**MONTGOMERY COUNTY HISTORIC PRESERVATION COMMISSION**  
**STAFF REPORT**

<b>Address:</b>	3820 Warner Street, Kensington	<b>Meeting Date:</b>	4/23/2025
<b>Resource:</b>	Primary One Resource <b>Kensington Historic District</b>	<b>Report Date:</b>	4/16/2025
<b>Applicant:</b>	Community Options (Juan Carlos Serrano, Architect)	<b>Public Notice:</b>	4/9/2025
<b>Review:</b>	HAWP	<b>Tax Credit:</b>	No
<b>Case No.:</b>	1111097	<b>Staff:</b>	Laura DiPasquale
<b>Proposal:</b>	Fenestration Alterations

**Figure 7: Pella casement size chart and key showing the proposed windows as the minimum size available to meet the 5.7 sq. ft. egress requirement identified by the applicants.**

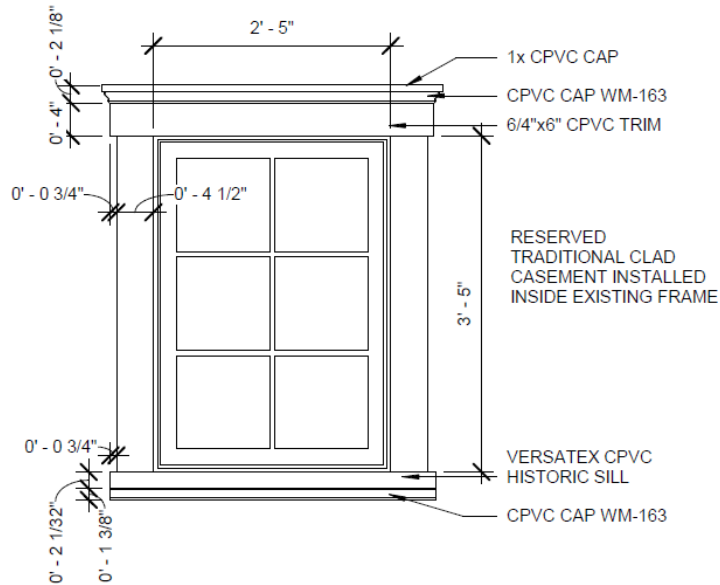
Regarding the window trim, staff recommends approval of the use of a substitute material in lieu of wood trim, provided it is a smooth finish and painted. The National Park Service's *Preservation Brief 16: The Use of Compatible Substitute Materials*, lays out three basic criteria that should be considered for the use of a substitute material. First, the material must match the appearance of the historic material. In this case, staff finds that the historic window trim profiles are simple and easily replicated in the proposed Versatex trim, which is available in a smooth finish and is paintable, and available in dimensions and profiles that match that of the historic trim. Secondly, the brief indicates that the substitute material must match the physical properties of the historic material, which is most critical when incrementally replacing components of a larger assembly. In this case, staff finds that the historic trim is no longer extant around these openings, so the potential differences in thermal and moisture-driven expansion and contraction between adjacent materials will be negligible. The NPS brief identifies the performance of the material over time as the third consideration. In this case, the proposed Versatex trim comes with a lifetime warranty. Staff finds that, even if the "lifetime" estimate is an exaggeration, the proposed material should last at least as long as modern wood window trim, which would require more frequent and challenging maintenance, given the attic location and proximity to the busy Connecticut Avenue. Staff finds that, owing to the simple profiles of the window trim, the absence of existing historic trim around these openings, and location of the windows at the attic level, provided the trim is a smooth finish and painted, the proposed cellular PVC trim is a compatible substitute material for use in this situation, in keeping with Chapter 24A-8(b)(2) and *Standard 6*.

**Figure 8: Proposed east window elevation (left) and existing west window elevation (right) for comparison of proportions and dimensions.**

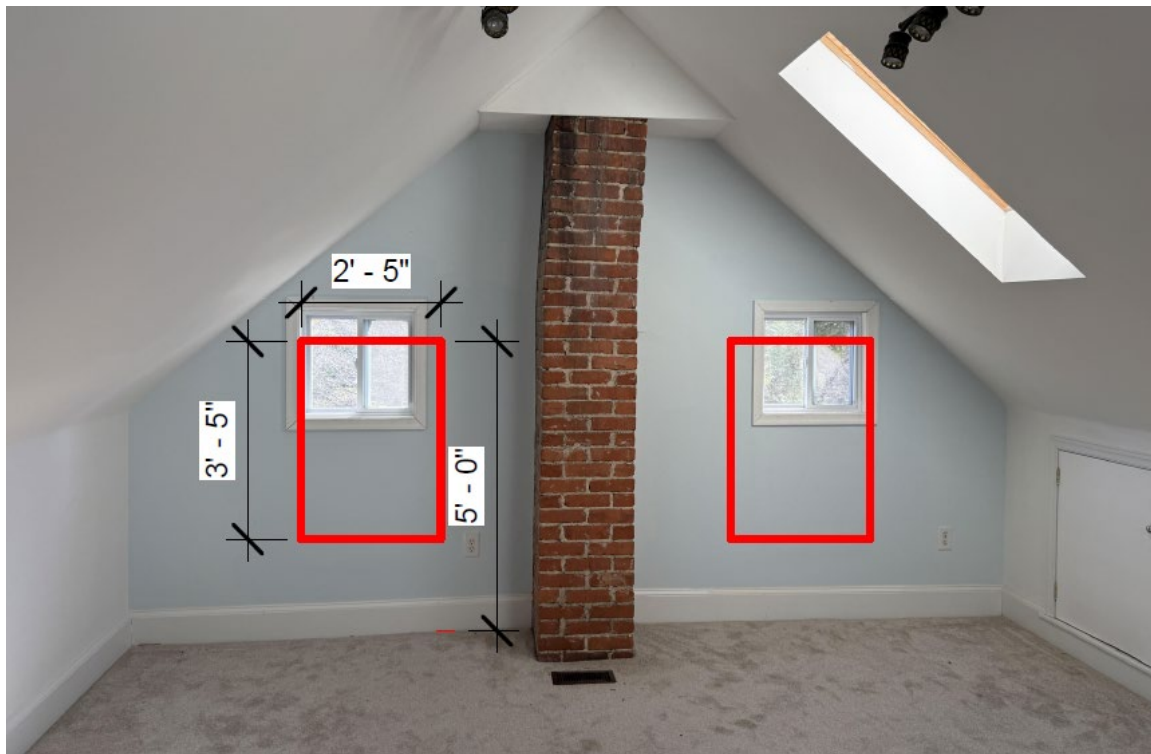
The current proposal is to remove the vinyl sliders and to install new Marvin Ultimate simulated-divided-light aluminum-clad casement windows with new cellular PVC trim (Versatex). The applicants justify the window enlargement with egress-compliant windows as a requirement of the Maryland Developmental Disabilities Administration and Office of Healthcare Quality guidelines for the room to be considered a bedroom. Staff finds that, while building code requirements such as egress are outside of the HPC's purview, the Secretary of the Interior's *Guidelines for Preserving, Rehabilitating, Restoring & Reconstructing Historic Buildings (Guidelines)*, which extrapolates upon the more succinct *Standards*, does acknowledge that code-required work may impact historic properties. The *Guidelines* include "recommended" and "not recommended" practices as they relate to code-required work. Regarding life safety, the *Guidelines* recommend "identifying the historic building's character-defining exterior features... which may be affected by life-safety code-required work," "complying with life-safety codes... in such a manner that the historic building's character-defining exterior features... and features of the site and setting are preserved or impacted as little as possible," and "working with code officials and historic preservation specialists to investigate systems, methods, or devices to make the building compliant with life-safety codes to ensure that necessary alterations will be compatible with the historic character of the building."<sup>1</sup> In their submission, the applicants identify the proposed windows as Pella Reserve Traditional Casement #2941 with a 6-light configuration measuring 29 inches wide by 41 inches in height. A size chart provided in the submission identifies the proposed windows as having a side pivot to comply with the means of egress of 5.7 sq. ft. Staff notes that the unit smaller, #2541, more closely replicates the dimensions and more vertical pane proportions of the historic windows, but only meets a 5.0 sq. ft. clear opening dimension (*Figure 7*). Staff finds that the proposed simulated-divided-light aluminum-clad windows generally resemble the profiles of historic wood windows, with a traditional depth and profile to the glazing (*Figure 11*). Staff finds that, absent the presence of the historic materials, which were previously removed, the overall design of the proposed windows, which generally resemble the proportions, features and details of the historic window openings, but are egress code-compliant in size, are compatible with the historic property, and help remedy a potentially unsafe condition, in keeping with Chapter 24A-8(b)(2) and (4).

2. The window trim must have a smooth and painted finish.
